**BEFORE THE PUBLIC UTILITY COMMISSION  
OF OREGON**

LC 76

2020 Integrated Resource Plan Update.

**SUBJECT:** CASCADE NATURAL GAS:  
(Docket No. LC 76)  
Acknowledgement of the 2020 Integrated Resource Plan Update.

Figure 1: Staff's Proposed Approach to Distribution System Project Analysis Post-CPP Adoption

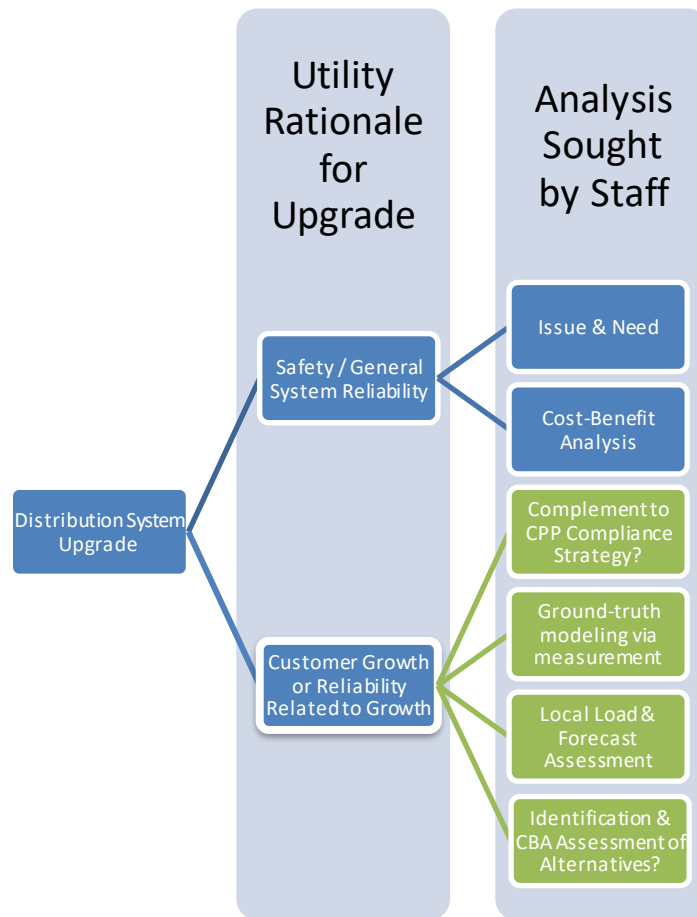
To this end, Staff's July comments put forth a high-level framework for how Staff plans to assess gas LDC's proposed distribution system upgrades going forward with new criteria found in green in Figure 1.<sup>10</sup>

The green boxes represent new criteria Staff plan to use when assessing distribution system projects driven by future customer growth. Attachment A to this memo details specific information Staff plans to request on any growth-driven distribution system project in the future. As Staff learns more and engages with IRPs and stakeholders, we envision this framework evolving. Staff is also open to future discussions about the alternative forums for the proposing and assessing gas distribution system projects, much like the electric utilities distribution system planning docket (i.e., UM 2005).

*Figure 3: Current Baker City System under CNG's Current Cold Weather, Design Day Parameters*

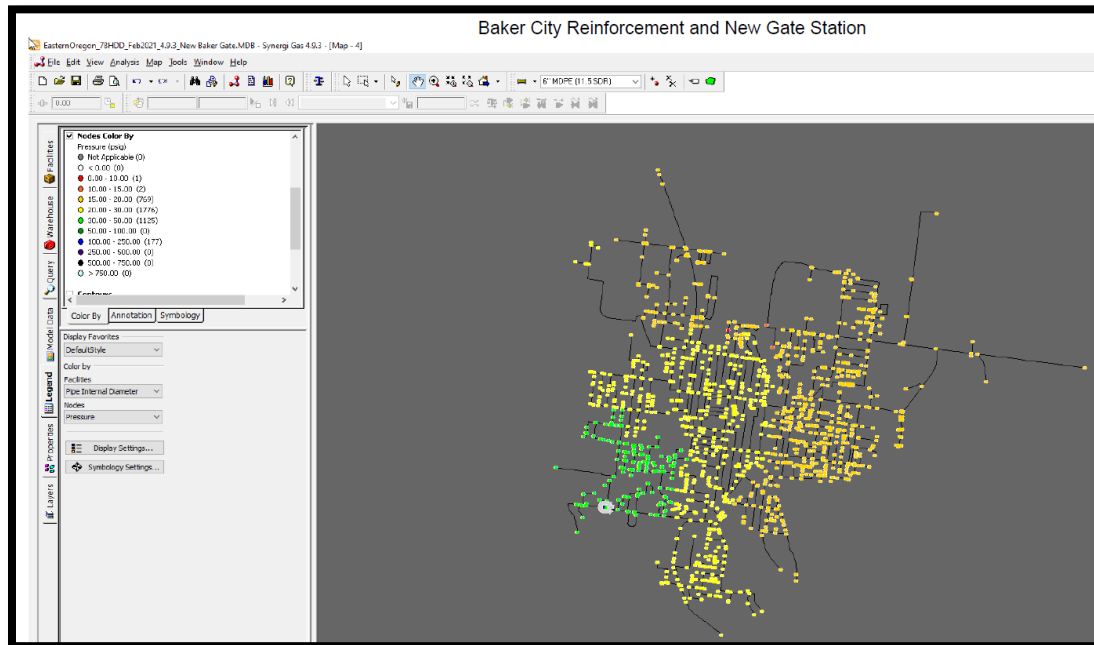
Cascade shared a revised screenshot in response to an IR using a more granular legend for the psig. The screenshot below shows how the **current** Baker City system looks under the Company’s **current** cold weather, design day parameters, **prior to** the proposed \$1.75 million reinforcement and gate project:<sup>21</sup>

There appears to be only one node fully below 10 psig during the design day event. Further, there are two nodes between 10 to 15 psig, with an additionally 760 between 15 to 20 psig. As such less than 1% of the Baker City nodes fall below 15 psig under the design day criteria. While future demand may drive the need for upgrades, especially if non-pipe alternatives are not explored and/or piloted, the near-term the need for the project does not appear imminent. Further, Cascade's planning engineers' filing only mentioned one other alternative investment: adding an additional 1,200 ft. of six inch pipe to the proposed projects. This would make the Baker City project even more expensive than the \$1.75 million cost initially proposed in the IRP Update.

Figure 4: IRP Update Figure 8 - Ontario Before Proposed Reinforcement

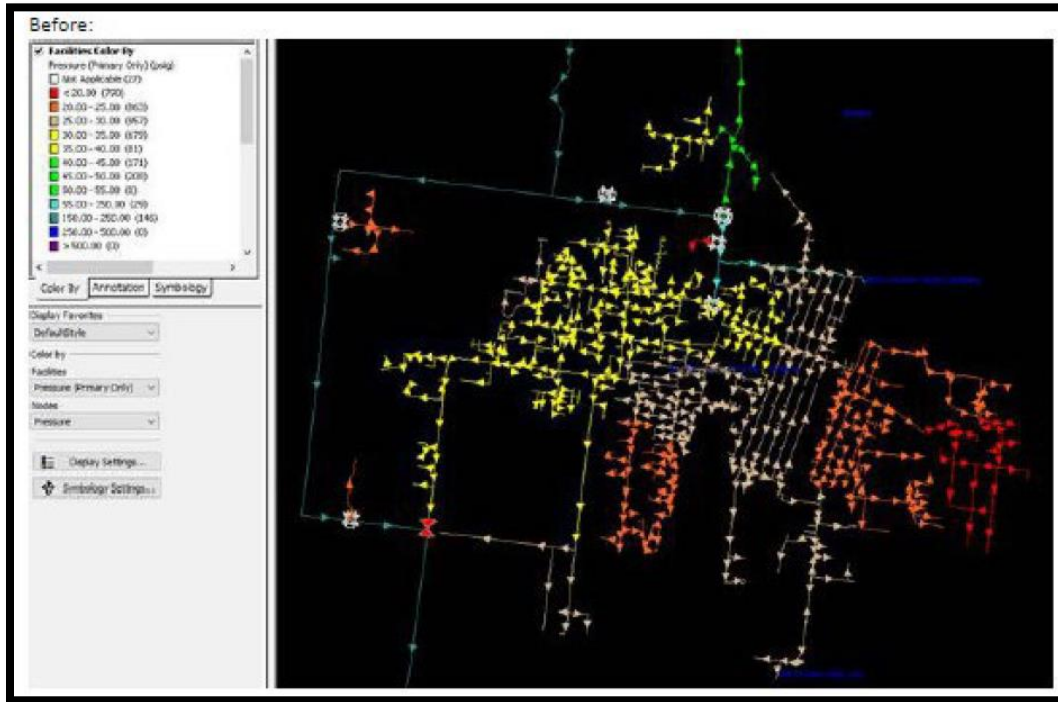
Figure 4 is from the IRP Update. In this system model any node equal to or below 20 psig on the cold weather, design day maximum appears in red. The second screenshot is with a more granular representation of the psig under the cold weather, design day constraint.

*Figure 5: Increased Granularity of Ontario psig Under Cold weather, Design Day Constraint*

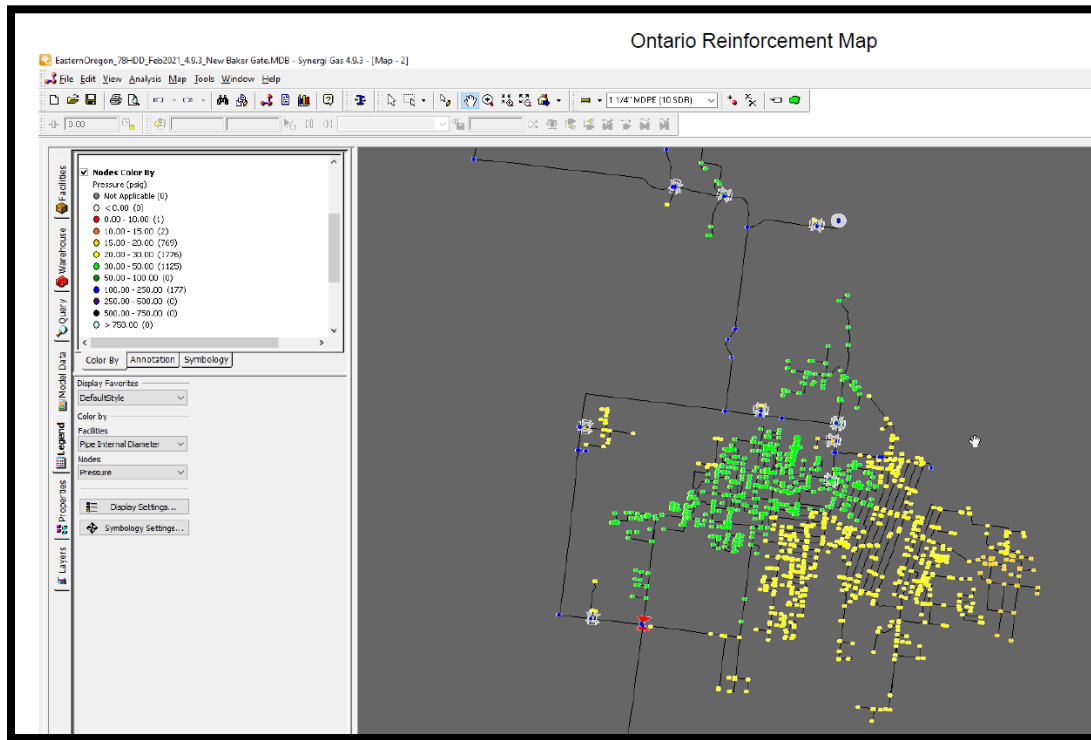
Note that only two nodes of the Ontario system appears to experience less than 15 psig under design day criteria currently. Further, Cascade notes that this is not a fast growing area.<sup>24</sup>

As such, this reinforces Staff’s belief that this proposed \$1.23 million project falls under the category of growth-driven and does not need to be acknowledged now. The project should demonstrate in a future IRP how it meets Staff CPP criteria for distribution system projects.

**Recommendation:** Do not acknowledge Ontario Reinforcement.
